State of New Mexico  
Energy, Minerals and Natural Resources Department

**RE: Comments on Regular Exploration Application, Tererro Exploration Project,  
Permit No. SF040ER, Comexico, LLC**

The *Hydrogeologic Resources Report for the Tererro Project in Santa Fe County, New Mexico*, dated October 2019, was received by MMD on October 18, 2019. The Hydro Report was prepared by SWCA Environmental Consultants for Comexico to fulfill the hydrology requirements under the National Environmental Policy Act (“NEPA”) permitting for the USFS and/or permitting by state and local agencies.

Figure 1: CoMexico LLC Potential Drill Sites for Tererro Exploration Project, Santa Fe County, New Mexico.

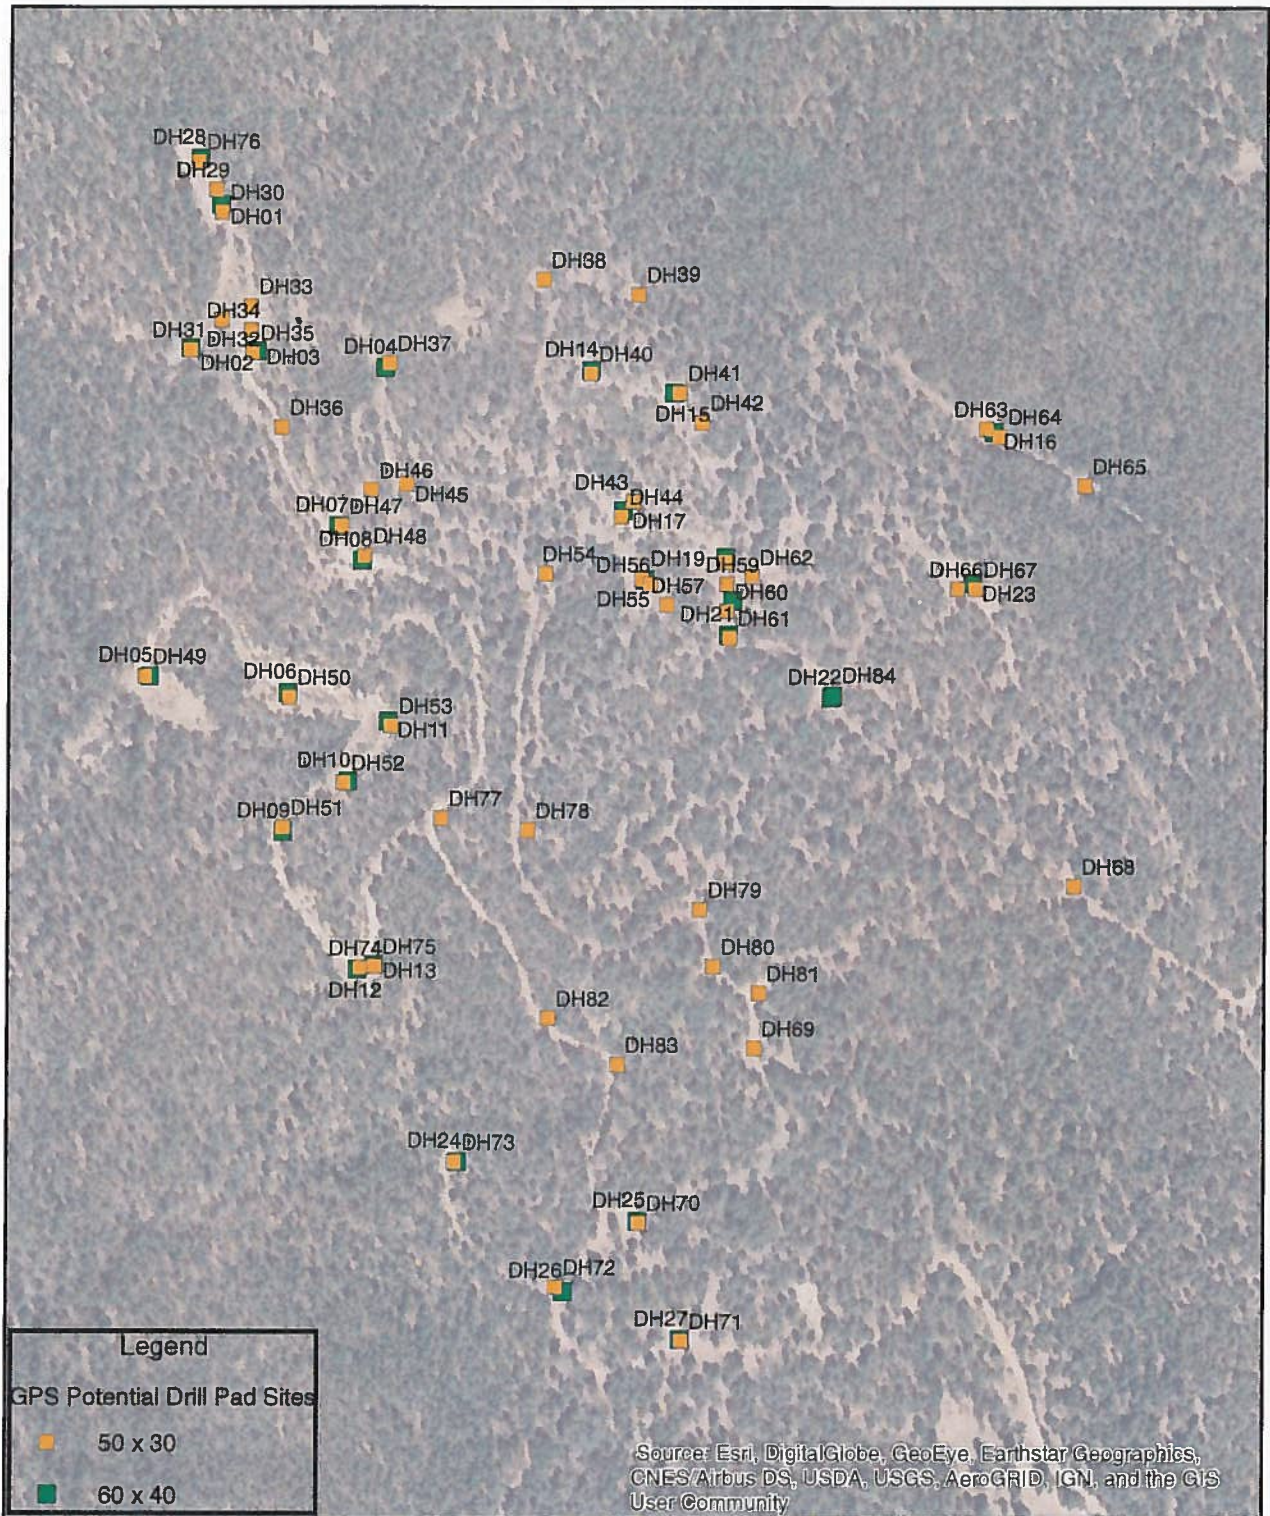
Comexico LLC proposed to drill up to 30 drill holes with depths ranging from 500 to 4000 feet deep and diameters ranging from 3 to 5.5 inches on up to 84 drill pads on land located at Township 17 North, Range 11 East, Section 01 (Figure 1). The land is owned by the United States Department of Agriculture, U.S. Forest Service and Santa Fe National Forest in Santa Fe County, New Mexico. The applicant proposes to undertake the exploration activities from October 1, 2019 to February 29, 2020 using air and fluid drilling methods. A core drilling rig (LF90 or equivalent), and/or a reverse circulation (RC) rig (Prospector 750 or Explorer 1500 or equivalent) may be used for drilling. In addition, two mud pits with dimensions of 5-10 ft by 5-10 ft by 5 ft deep will be dug at each site and lined with plastic to keep the fluid from seeping into the ground. The mud pits will allow for fluid recirculation during drilling and will reduce the required amount of water needed per drill hole.

The supplemental information is a modification to the application that reduces the proposed number of drill pad locations from 84 to 36 for drilling up to 30 drill holes.

Available data in the New Mexico Water Rights Reporting Systems (NMWRRS) database show that the nearest existing water well at the proposed exploration permit area is well UP 00826 which the applicant proposes to use for their operations. Well UP 00826 has a total depth of 239 feet and a recorded depth to water of 95 feet below ground level (bgl). The well is located at an elevation of approximately 8,400 feet above mean sea level (amsl).
